REGULATOR INFORMATION DISTRIBUTION SYSTEM (RIDS)

SUBJECT: Forwards info requested by Human Factors Branch during 820701 telcon.

SUSQUEHANNA STEAM ELECTRIC STATION  
RESPONSE TO NRC REQUEST FOR HUMAN FACTORS INFORMATION Docket Nos. 50-387  
ER100450 FILE 841-2 PLA-1163 50-388

Figure 7

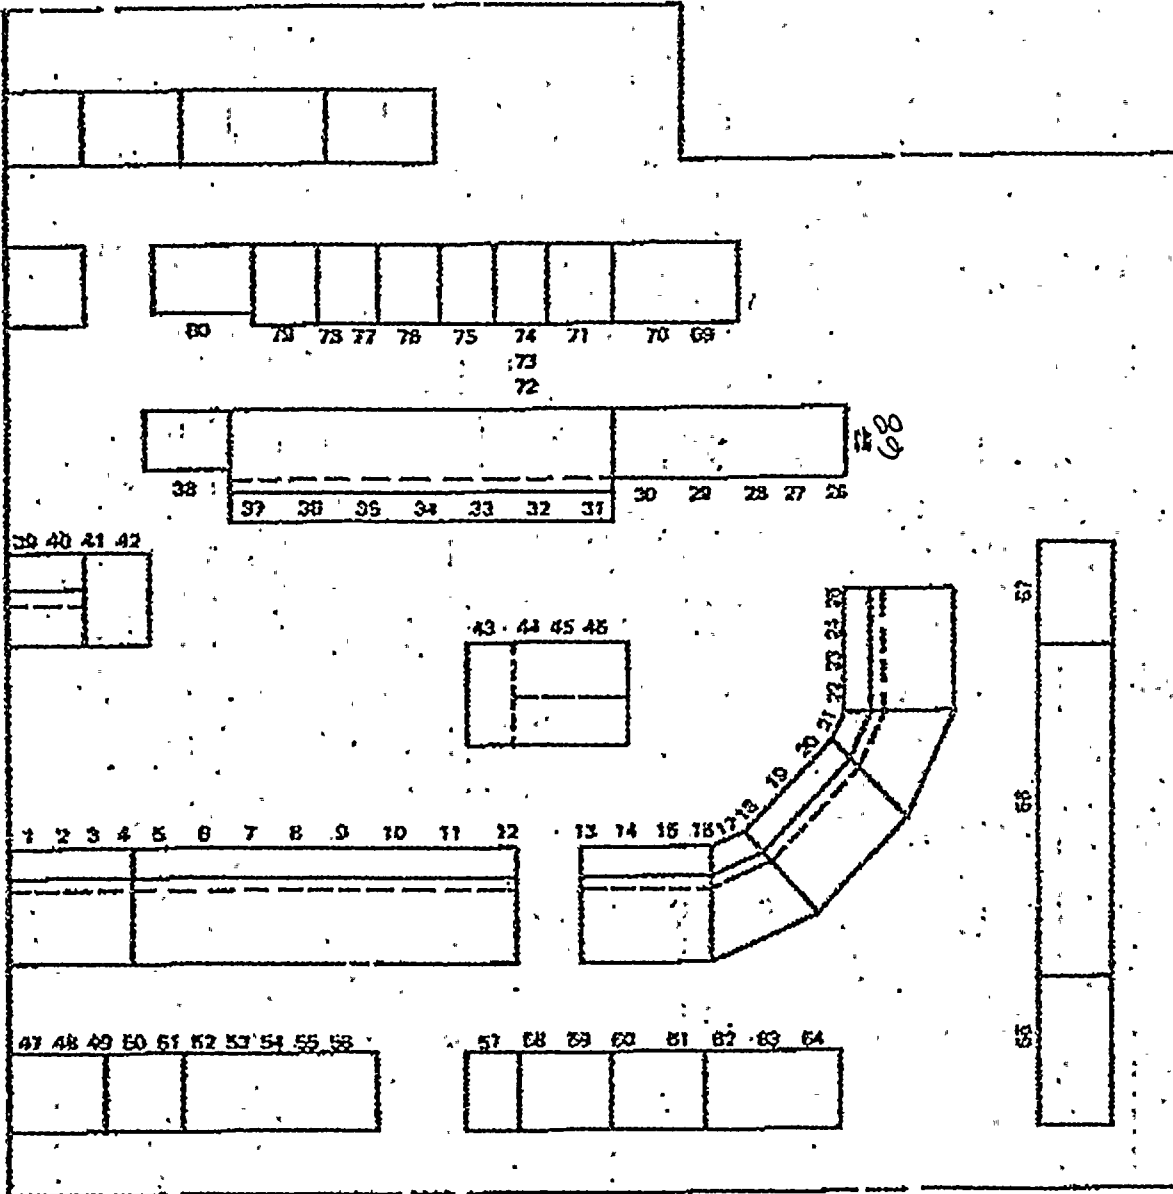
Attached you will find the data sheets for the sound level survey performed by General Physics on June 2, 1982. The positions indicated on the data sheet correspond to the same positions used by GP in the preliminary sound level measurements taken for our preliminary report. (Attached). Only five out of the 80 measurements taken on 6/2/82 were above the recommended 65 dBA maximum. Those higher (66 dBA and 67 dBA) were attributable to construction noise occurring at the time of measurement, not to permanent acoustical problems.

The data sheets do not show GP's tests of the annunciator system. From discussions with GP, the main annunciators were said to measure 73 dBA which is 8 dBA above the projected 65 dBA maximum. A completed report of sound level measurements will be made available to you once it is completed by General Physics. The annunciators were demonstrated to the Resident Inspector and no deficiencies were noted.
